PROBLEM:

On early H1 and H2 models, there have been problems of gear engagement resulting from excessive play in the stationary gears on both the drive and output shafts.

SOLUTION:

A. CORRECTIVE ACTION FOR 4TH GEAR:

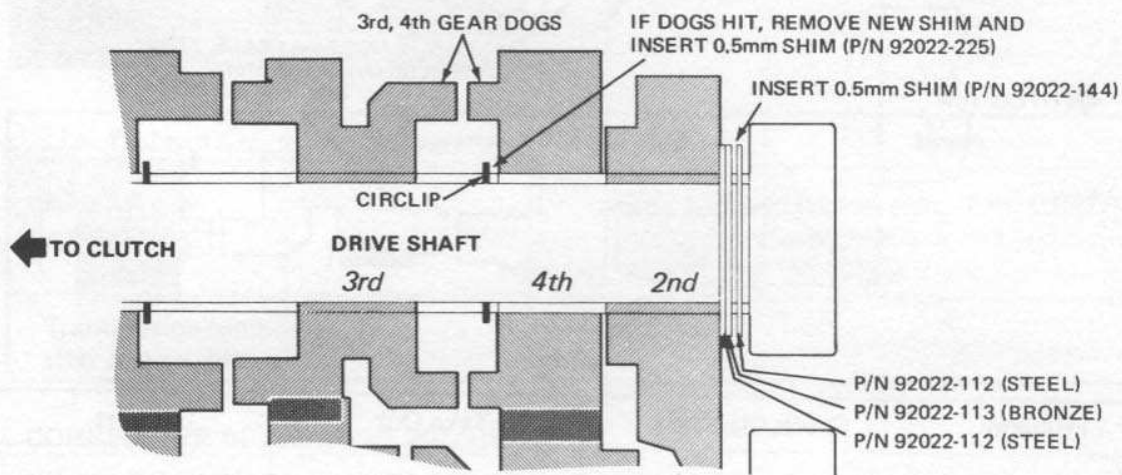
Several shims have been added on both output and drive shafts in order to eliminate specific problems. These corrections have been applied to all H1's from engine numbers KAE-59017 and up, and to all H2's from the beginning of production.

1. Insert an 0.5mm shim (P/N 92022-144) between second gear and the bearing on the drive shaft. The shim goes between the bronze and steel washers already present. This moves second and fourth gears over toward the third gear slider, making a more positive engagement of fourth. If the shaft turns hard, take the shim back out.
2. If fourth gear dogs hit third gear dogs after adding the shim, then take it back out and add a 0.5mm shim (P/N 92022-225) between 4th gear and the circlip. This keeps the sloppiness out of the gear without forcing the dogs together.

4th Gear Problem	Clearance	Take Out	Insert
Jumps out of 4th gear.			0.5mm shim (92022-144) along with shims already present between second gear and end bearing on drive shaft.
4th gear dogs hit 3rd gear dogs in neutral after adding shim.		Remove new 0.5mm shim between 2nd gear and end bearing on drive shaft.	Add 0.5mm shim (P/N 92022-225) between 4th gear and circlip on drive shaft.

E. CORRECTIVE ACTION FOR 3RD GEAR:

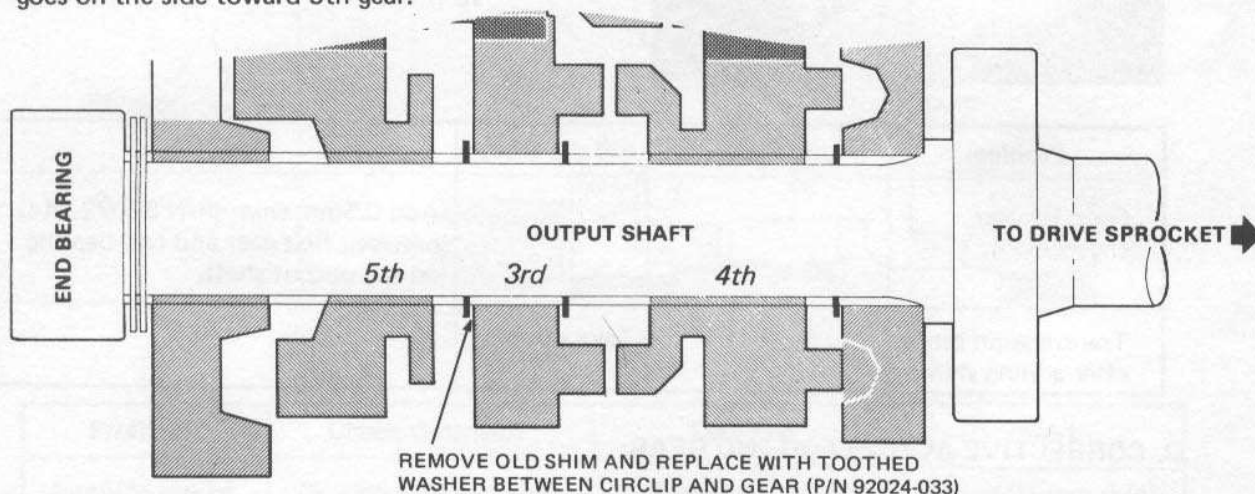
The problem with third gear has primarily been the result of the shim between 3rd gear and the circlip spinning and wearing through the circlip. This causes third gear to move away from the slider and hop out of gear. The solution is to remove the standard shim (P/N 92022-076) and replace it with a toothed washer which cannot rotate (P/N 92024-033). The new washer goes on the side toward 5th gear.

Problem	Take Out	Insert
Jumps out of 3rd gear.	Remove 1.0mm shim between 3rd gear and circlip on output shaft.	Insert 1.0mm toothed thrust washer (P/N 92024-033) between 3rd gear and circlip (5th gear side).
